COUNTY HOUSE, FRIAR STREET, READING, RG1 1DB – DAYLIGHT AND SUNLIGHT AMENITY

TFT have been instructed by Columbia Threadneedle to undertake a non-technical desk-top review in consideration of Daylight and Sunlight amenity, with regards to the Studio RBA's residential proposals for County House, Friar Street, Reading, issued to TFT on 16th July 2021.

Figure 2: 3D site view of Imperial House (Google 2021).

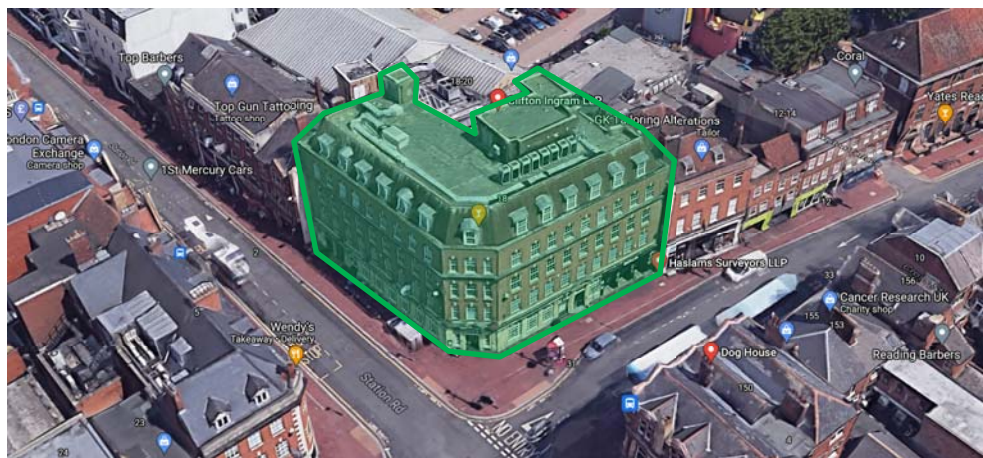
As can be seen from the images above, County House is a large L-shaped building, situated on the corner of Station Road and Friar Street, and at the corner of a block of terraced commercial buildings, sharing boundary walls to the north and east. The building is fully extended at ground level but includes a rear courtyard to the north. From first floor it enjoys almost unobstructed views to the north and east, but to the south, and west it overlooks buildings of a similar size and scale.

By reference to the BRE's initial 25° obstruction angle test, if the 25° angle were struck from any first-floor window of County House, this test would be satisfied, although to the south and west facing, street fronting elevations external obstructions are present due to the neighbouring buildings to the south and west across the road. Nevertheless, given streets in Reading town centre are wider than is typical in other town centres, good access to daylight for windows on all elevations of County House are possible. As a result, the fenestration will enjoy excellent Vertical Sky Component (VSC) values which are likely to achieve or exceed the guidance target value of 27% VSC. The VSC value is one the
